# SUPPLEMENTAL INSTRUCTION

PROJ.: **Boys and Girls Club Prince of Wales**  
PROJ. No.: **1716**  
DATE: **September 14, 2018**  
S.I. No. **S.I. - 043**

Revision to Exhaust and Transfer Fan Control

## Electrical Contemplated Change Notice (ECCN)

Figure 1 Typical Control Wiring

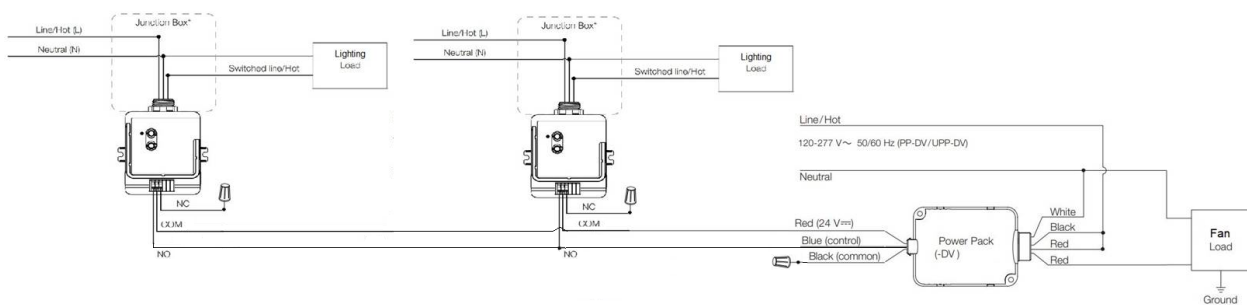
1. See Drawings E-5 & Lighting Control Shop drawings
  - a. Exhaust fan control:
    - i. Circuit Exhaust fan on same circuit as transfer fan, G1-54
    - ii. Install timer switch provided by Mechanical contractor, as indicated on mechanical shop drawings.
  - b. Transfer Fan control:
    - i. Delete: Occupancy sensors (LOS-CDT-2000-WH) in rooms Boys (117), Girls (118), M Change (120), F Change (121)
    - ii. Add: wireless occupancy sensors LRF2-OCR2B-P-WH (replace deleted)
    - iii. Delete: 3 Power Pack PP-DV
    - iv. Add: 4 Wireless power pack RMJS-5RCC01-DV-B
    - v. Relocate: 1 Lutron Power pack PP-DV power pack to exhaust fan
    - vi. See wiring diagram supplied by Lighting Agency (Flux), add control cables (see below for typical wiring)
